TECHNICAL SERVICE BULLETIN, VIN: WSB-09 Open Trail DC-DC Replacement

Technical Service Bulletin WSB-09 Repair Instructions

Purpose: To swap the DC-DC converter for the Open Trail units to ensure proper functionality.

Figure 3

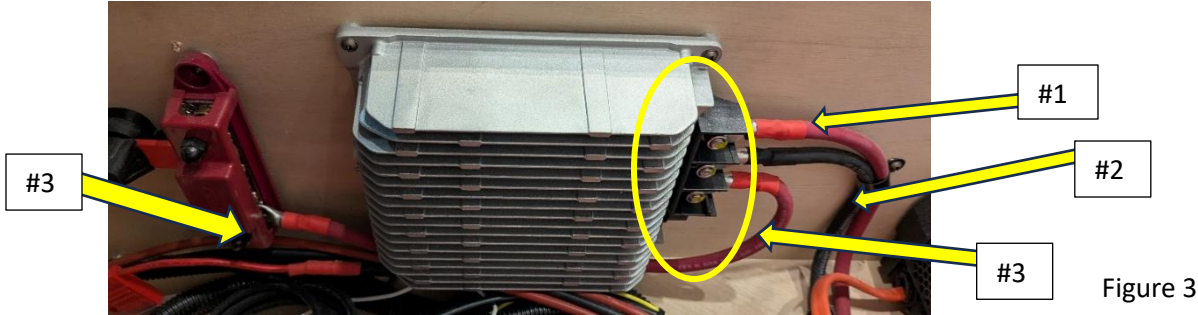
2. Remove the existing DC-DC converter, first removing the cable ends and nuts holding the cables, see figure 3, to the component body and then removing and discarding the converter.

3. Remove and discard the output cable, figure 3 #3, that connected the silver DC-DC converter to the 12-V positive output buss bar terminal.
4. Install 2 new DC-DC converters, part number 5110414, using wood screws to secure. See Figure 4.

Figure 5b

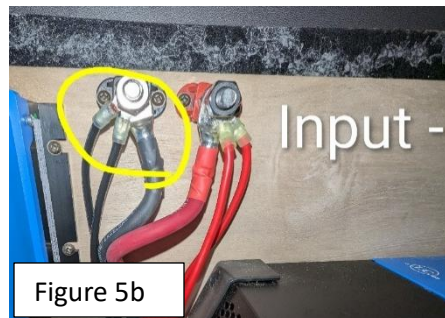
5. For positive input wiring:
 - a. Install the red single point power post to the electrical box wall as shown in figure 5a.
 - b. Fabricate 2 positive input harnesses using 10-gauge wire to connect each DC-DC to the red, single point power post. Each harness should be connected to a ring connector on one end and have approximately 1/4-inch stripped wire on the other end and contain an inline fuse holder containing a 10-amp fuse.
 - c. Connect the positive input cable previously connected to the DC-DC, see figure 3 #1, and the ring end of each 10-gauge wire harness from step 5b to the positive red, single point power post, and torque nut to 115 in-lbs.
 - d. Insert the other end of each 10-gauge wire harness into the positive input wire screw clamp connector on each DC-DC. Complete a pull test to make sure the wire is secure in the clamp of each DC-DC as shown in figure 5b.

6. For negative input wiring:
 - a. Install black single point power post as shown in figure 5b.
 - b. Fabricate 2 negative input, 10-gauge wire harnesses. Each harness should be connected to a ring connector on one end and have approximately 1/4-inch stripped wire on the other end.
 - c. Connect the negative input cable previously connected to the DC-DC, see figure 3 #2, and the ring end of each 10-gauge wire harness from step 6b to the negative input single point power post, and torque nut to 115 in-lbs, see figure 5b.

Figure 6

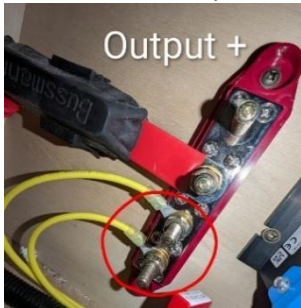
- d. Insert the other end of each 10-gauge wire harness into the negative input wire screw clamp connector on each DC-DC. Complete a pull test to make sure the wire is secure in the clamp of each DC-DC.
7. For positive output wiring:
 - a. Fabricate 2 positive output wire harnesses. Each harness should be connected to a ring connector on one end and have approximately 1/4-inch stripped wire on the other end.
 - b. Connect the ring end of each wire to the 12-V positive output buss bar terminal as shown in figure 6 and torque nut to 115 in-lbs.
 - c. Insert the other end of each 10-gauge wire harness into the positive output wire screw clamp connector on each DC-DC. Complete a pull test to make sure the wire is secure in the clamp.

Figure 8a

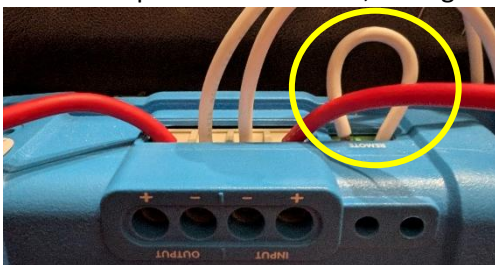
9. Fabricate a remote jumper wire from any of the 10-gauge wire and install into the wire screw clamp connectors of the remote ports shown below, see figure 8a and 8b.

Figure 10

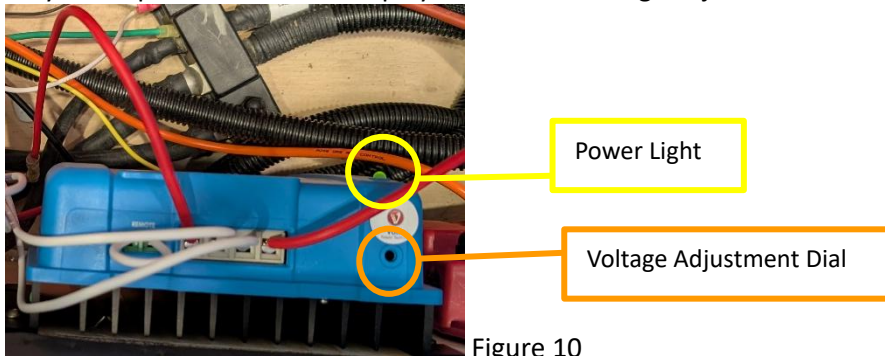
13. Starting with the DC-DC that has an illuminated power light, see figure 10, adjust the voltage adjustment dial with a very small flat or Phillip's head screwdriver to get 12.5V-12.8V on the home screen of the Spyder Control Screen. Navigating off and on the home screen will help monitor current voltage, if not navigating off the home screen it may take up to 5 minutes to display the current voltage adjustment.
